Our Case Number: ABP-316272-23

Re: Bus Connects Templeogue/Rathfarnham to City Centre Core Bus Corridor Scheme
Templeogue/Rathfarnham to City Centre

Templeogue / Rathfarnham to City Centre Core Bus Corridor Scheme

Picture of junction Grove Park with Grove Road

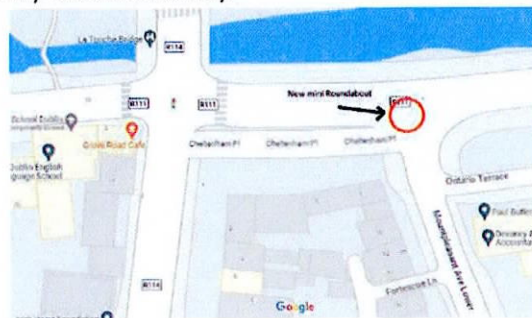
As a result of the bus gate on Lower Rathmines Road Grove Park will see increased traffic. A yellow grid box on the junction of Grove Park and Grove Road will be required to facilitate vehicles turning right & make it safer. This junction is usually backed up along Grove Road as far as this junction from the traffic lights at Portobello Bridge. Although a reduction in traffic is predicted on this stretch of road it's not guaranteed. We will need a yellow box marked on the road to facilitate turning right.

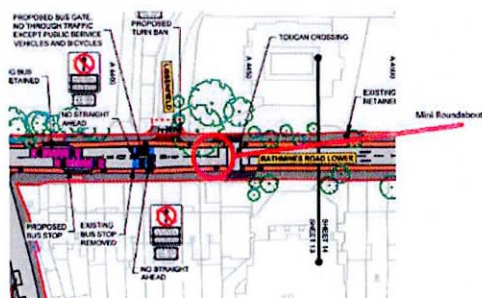
Access should be allowed through the bus gate for bin trucks.
